## **PROPOSED CHANGES TO 521 CMR AS OF FEBRUARY 17, 2005:**

**All changes are noted by being in all capitals and bold, italic font.**

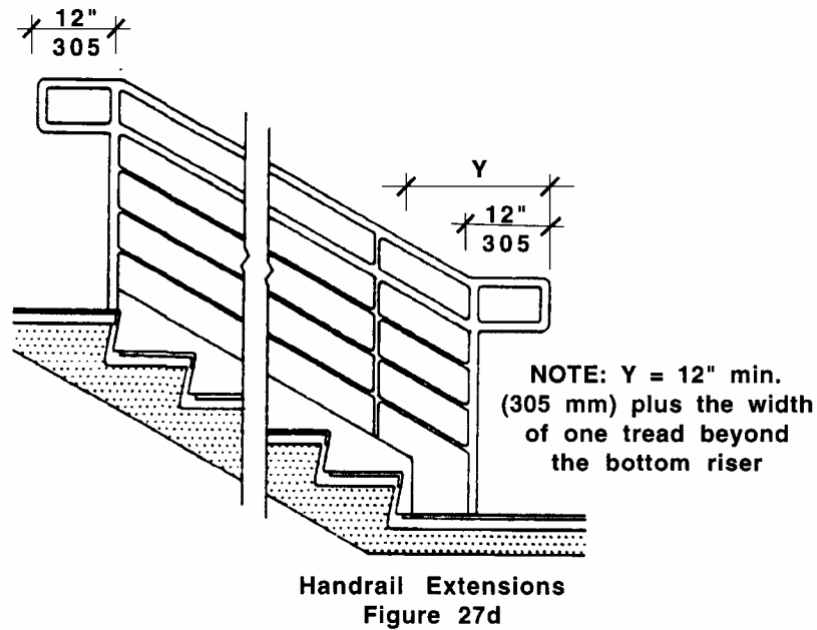
## **26.6 MANEUVERING CLEARANCE**

*A minimum clear floor area shall be provided on both sides of all doors and gates.*

**EXCEPTION: DOORS EQUIPPED WITH AUTOMATIC OPENING DEVICES ARE EXEMPT FROM 521 CMR 26.6.3, 26.6.4, 26.8**

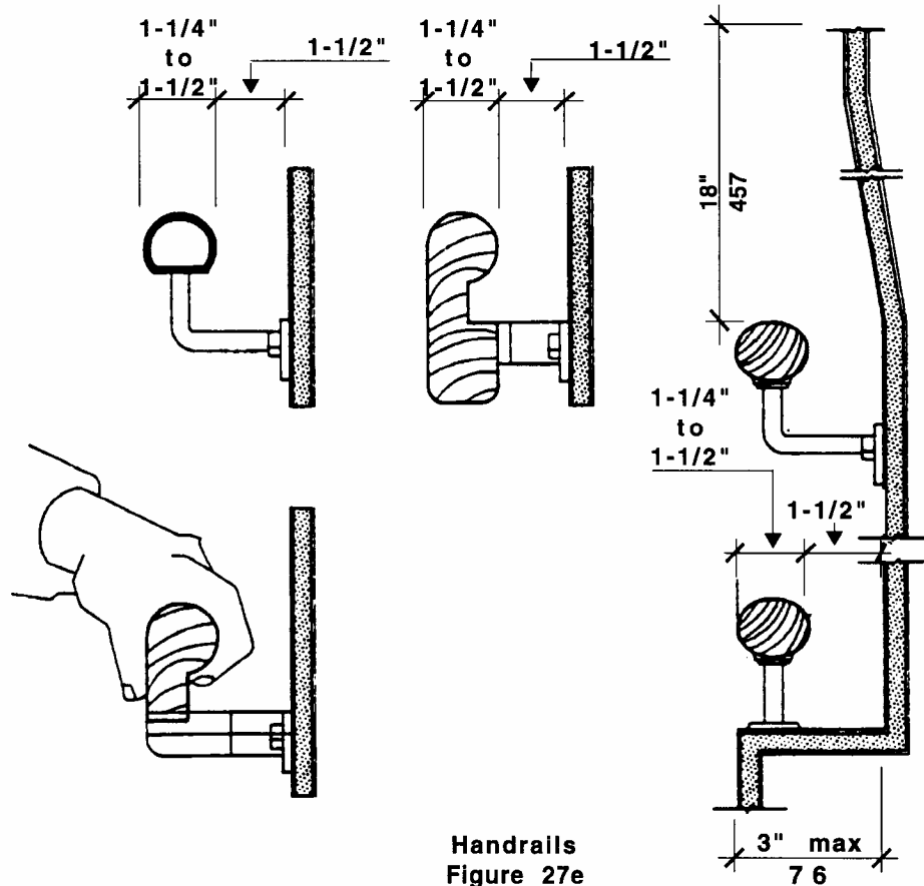
27.4.4 Size: **HANDRAILS SHALL HAVE A CIRCULAR CROSS SECTION WITH AN OUTSIDE DIAMETER OF 1-1/4 INCHES (32MM) MINIMUM AND 2 INCHES (51MM) MAXIMUM.**

27.4.5 Shape: The handgrip portion of the handrail shall be round or oval in cross-section. See **Fig. 27e**.
